# UNITED STATES PATENT AND TRADEMARK OFFICE

APPLICATION NO.	FILING DATE	FIRST NAMED INVENTOR	ATTORNEY DOCKET NO.	CONFIRMATION NO.
10/616,707	07/10/2003	Refaat S. Fanous	2682/102	1553
2101	7590	08/11/2005	EXAMINER	
BROMBERG & SUNSTEIN LLP			ARAJ, MICHAEL J	
125 SUMMER STREET			ART UNIT	
BOSTON, MA 02110-1618			PAPER NUMBER

## Office Action Summary

## **DETAILED ACTION**

Figure 1

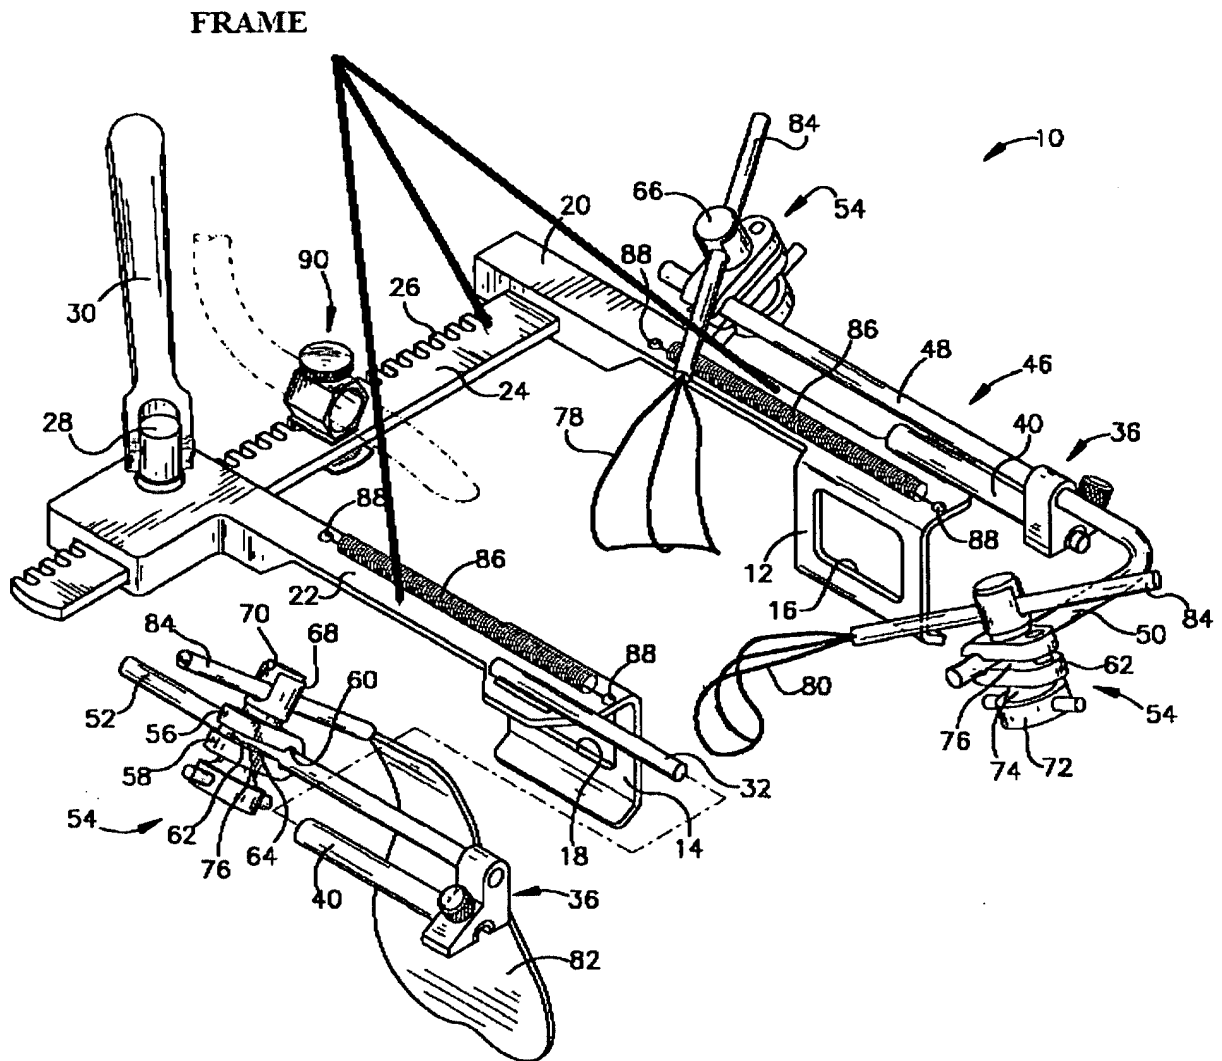
Santilli et al. discloses a retraction device (10) comprising a frame (see Figure 1 below) hinged (28) on a handle (30), where the frame includes a track (50) and a least one or more anterior retractors with a curved blade (78, 80, 82), attached to the retractor-handle (84) that is attached to the frame with a jig (54), where the retractor (10) is slidably mounted on the track (50) by a jig that does not contact the patient; a ratchet mechanism (26); and a support element (90) attached to the handle for retaining the device in a position .

Figure 2

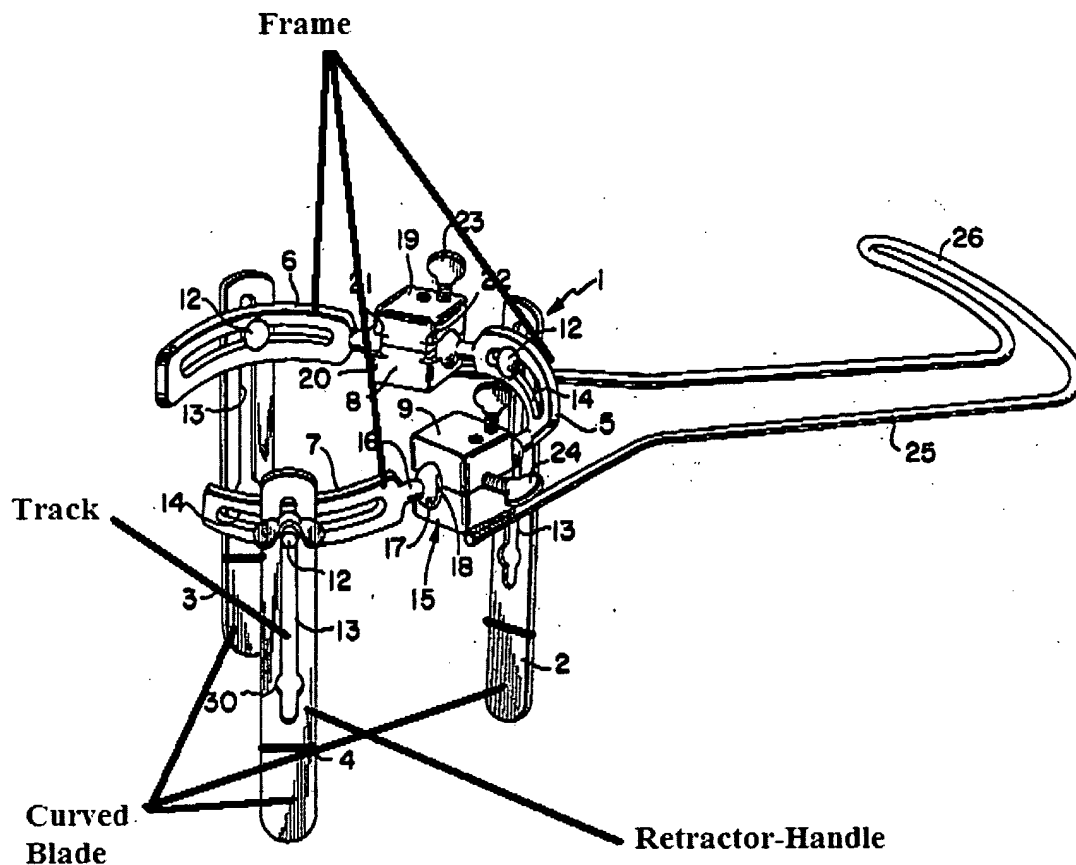
Karlin et al. discloses a retraction device (1) comprising a frame (see Figure 2 below) hinged (18) on a handle (25), where the frame includes a track (see Figure 2) and a least one or more anterior retractors with a curved blade (see Figure 2), attached

to the retractor-handle (see Figure 2) that is attached to the frame with a jig (12), where the retractor is slidably mounted on the track by a jig that does not contact the patient; the track includes a groove/slot (14) for slidably mounting the jig (12) to the track; a support element (9) attached to the handle (25); a retractor-handle that has a groove along a portion of a length of it, where the groove (14) has a differential width (30); and the retractor is configured with a curved blade forming a groove capable of supporting another blade.
